Deficiency Response List
Task ID #3016
Bath House Parking Lot Expansion

SECTION D-D'
SEDIMENT POND "C"

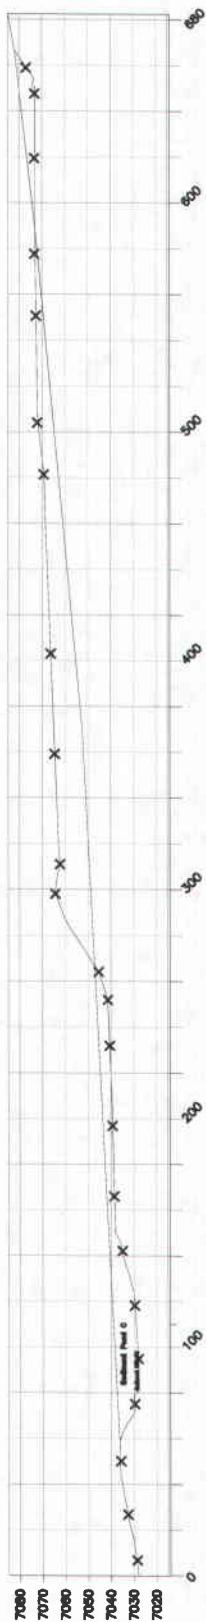
- D. The permittee must update the Sediment Pond “C” calculations within Appendix 7-F of the MRP. The Permittee must demonstrate that Sediment Pond “C” has the storage capacity to handle the increase in storm water volume that will be generated from the parking lot expansion.**
- R. Please find the revised Sediment Pond “C” Calculations for Storage Capacity included in this response.

SECTION E-E'

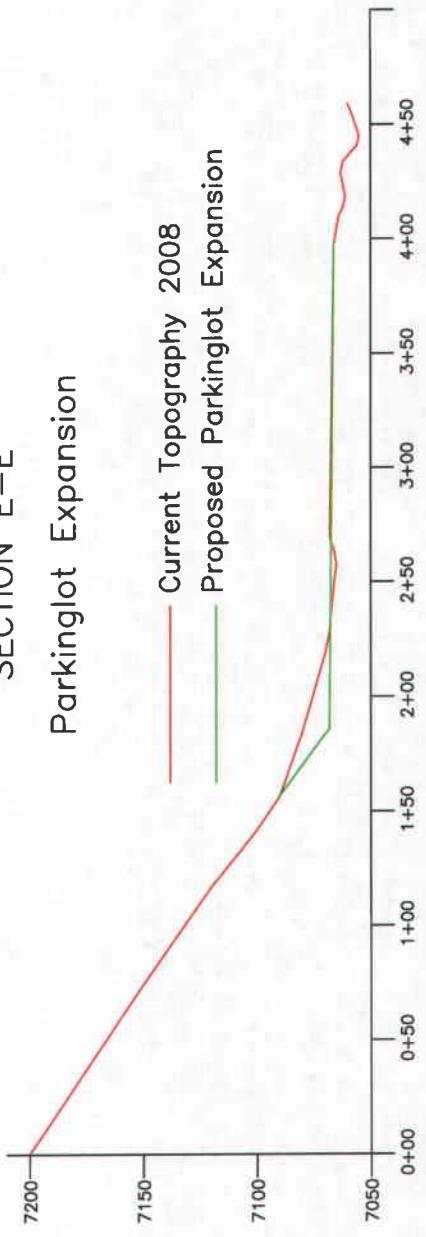
- D. The permittee must provide the Division with a map that clearly indicates sufficient slope measurements or surface contours to adequately represent the existing land surface configuration of the proposed permit area for at least 100 feet beyond the limits of mining disturbance.**
- R. Please refer to the revised Plate 2-3B, which shows extended topography to the west and a cross-section E-E' located on Page 5I-78 also included in this response.**

Figure 7-15A Cross-Section A-A' Culvert C-14D

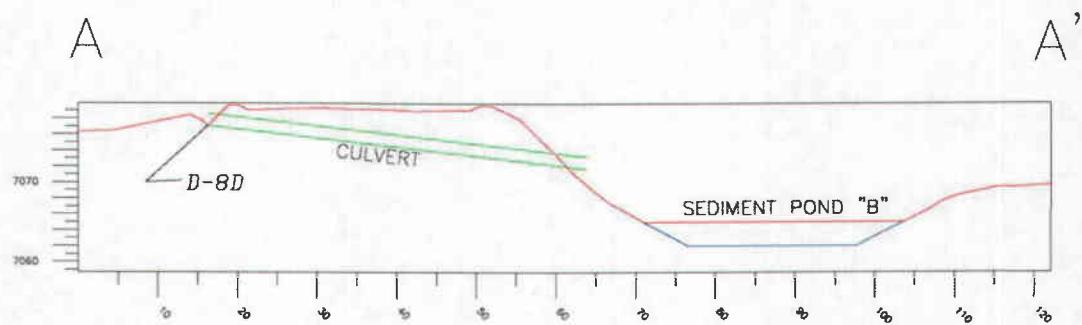
- D. The Permittee needs to modify the language on page 7-135 that describes culvert C-14D. The Language should make it clear to the reader as to what is currently in use at the site. Future tense is utilized in describing the 8" concrete slab associated with the removed water bar.**
- R. Please find the revised page 7-135 with the corrected language attached to this response.**
